PROJECT: Mabel Hoggard Elementary School

SUBMITTAL: Supplement

| CITY OF LAS VEGAS<br>INTER-OFFICE MEMORANDUM | | | DATE:<br>June 23, 2020 |
| **SUBJECT:** | Drainage Study for:<br>**Mabel Hoggard Elementary School** | | **COPIES TO:**<br>Atkins |

GRADING PLAN 1

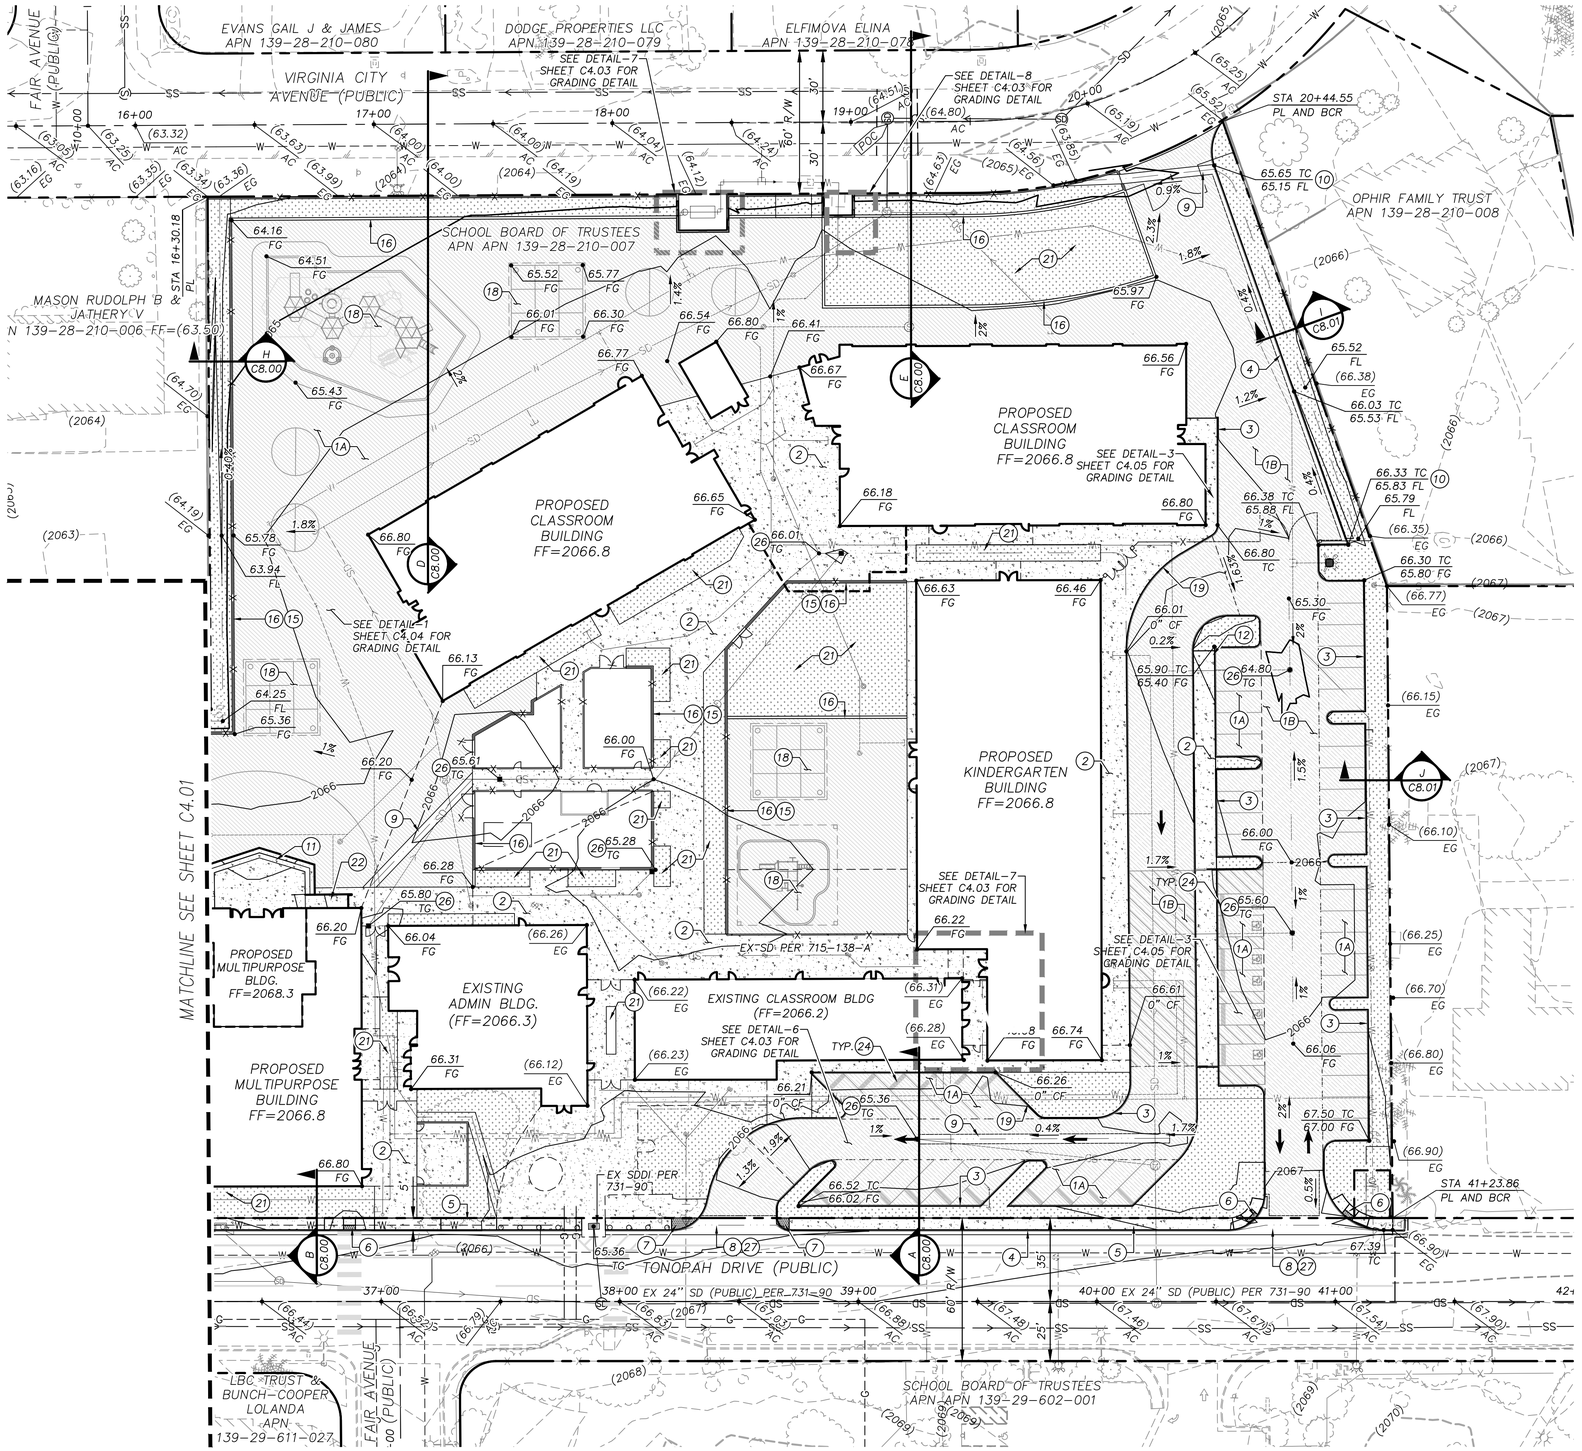
2. **Sheet C4.01 and Sheet C4.02**: A proposed grate type inlet (TG 61.80) at the east boundary on Sheet C4.01 is at a low point which does not appear to have an emergency overflow path in case the inlet is totally clogged. The ponding depth will be about 3' before the drainage overtops a high point (FL/HP 64.74) to the south. This ponding depth will inundate a substantial area of the parking lot at the north end of the school site which is unacceptable.

2. **Sheet C4.01** and **Sheet C4.02**: A proposed grate type inlet (TG61.80) at the east boundary on **Sheet C4.01** is at a low point which does not appear to have an emergency overflow path in case the inlet is totally clogged. The ponding depth will be about 3' before the drainage overtops a high point (FL/HP 64.74) to the south. This ponding depth will inundate a substantial area of the parking lot at the north end of the school site which is unacceptable.

2. **Sheet C4.01** and **Sheet C4.02**: A proposed grate type inlet (TG61.80) at the east boundary on **Sheet C4.01** is at a low point which does not appear to have an emergency overflow path in case the inlet is totally clogged. The ponding depth will be about 3' before the drainage overtops a high point (FL/HP 64.74) to the south. This ponding depth will inundate a substantial area of the parking lot at the north end of the school site which is unacceptable.

PLAN AND PROFILE 1
TONOPAH DRIVE STA 31+00 TO 37+50

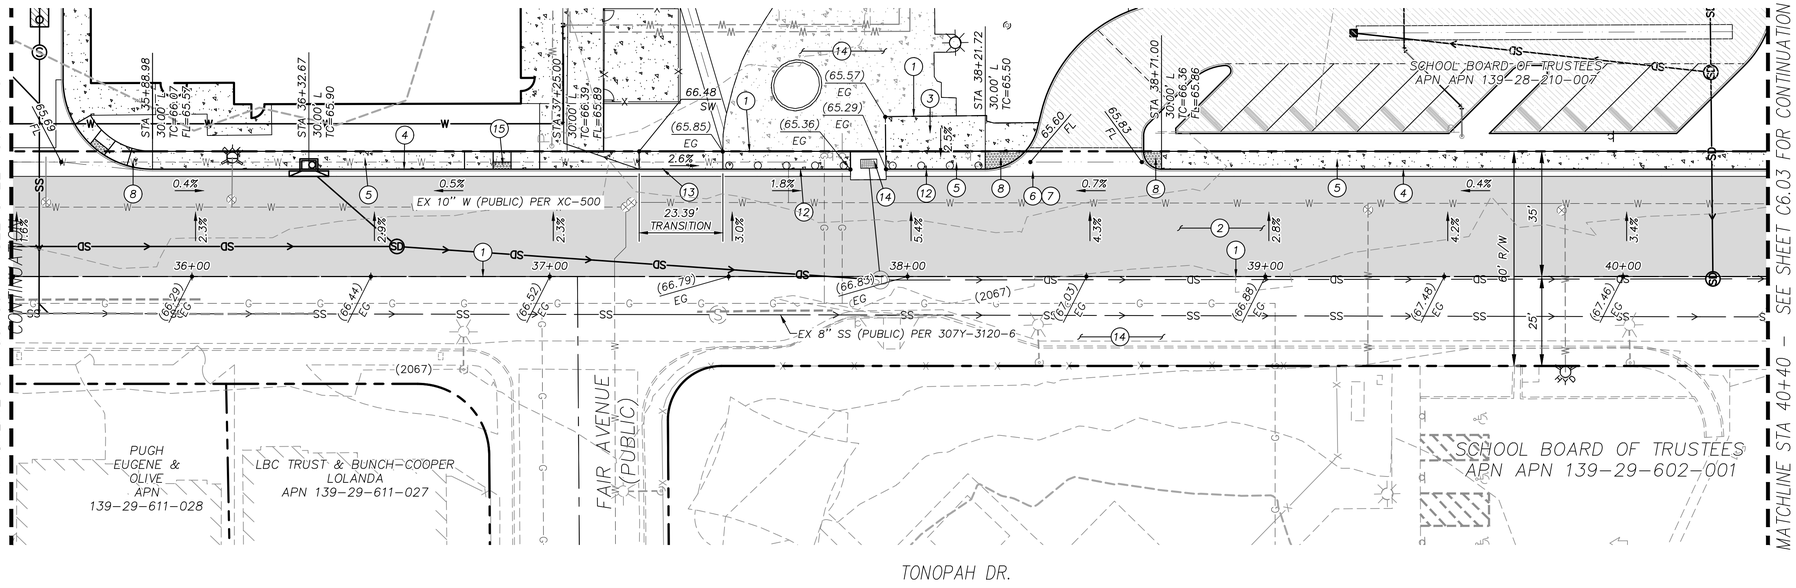
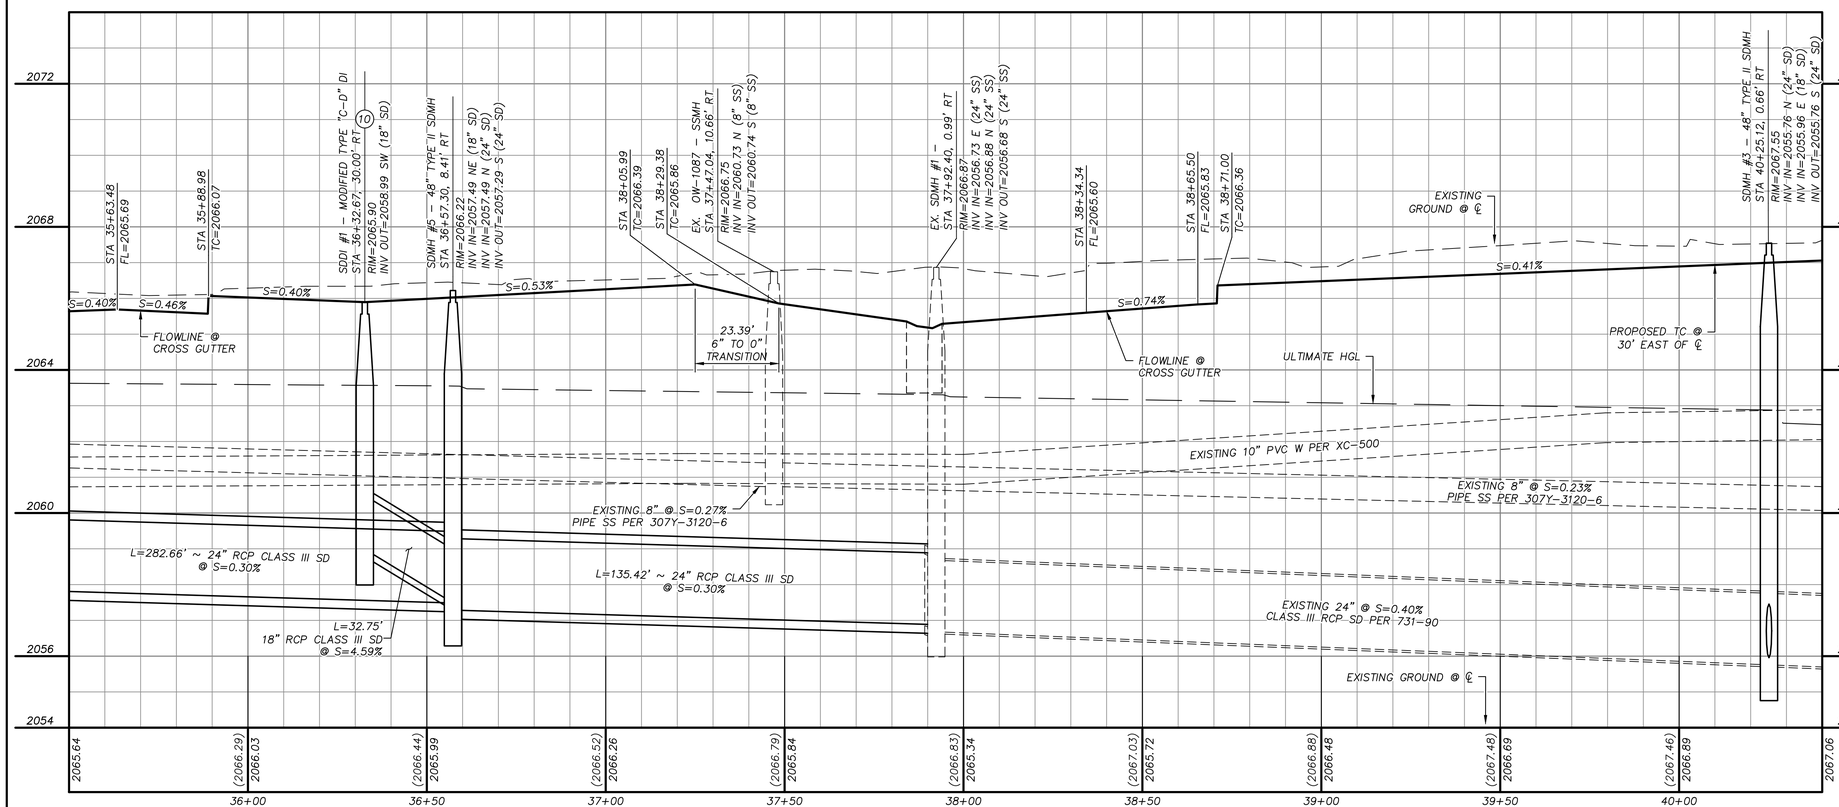
4. **Sheet C6.01 & Sheet C6.02**: Label the depth of the two proposed drop inlets in *Tonopah Drive*. Provide Street Name on all pertinent plan & profile sheets.

4. **Second Request: *Sheet C6.01 & Sheet C6.02***: *Label the depth of the two proposed drop inlets in Tonopah Road. Provide Street Name on all pertinent plan & profile sheets.*

4. **Second Request: *Sheet C6.01 & Sheet C6.02***: *Label the depth of the two proposed drop inlets in Tonopah Road. Provide Street Name on all pertinent plan & profile sheets.*
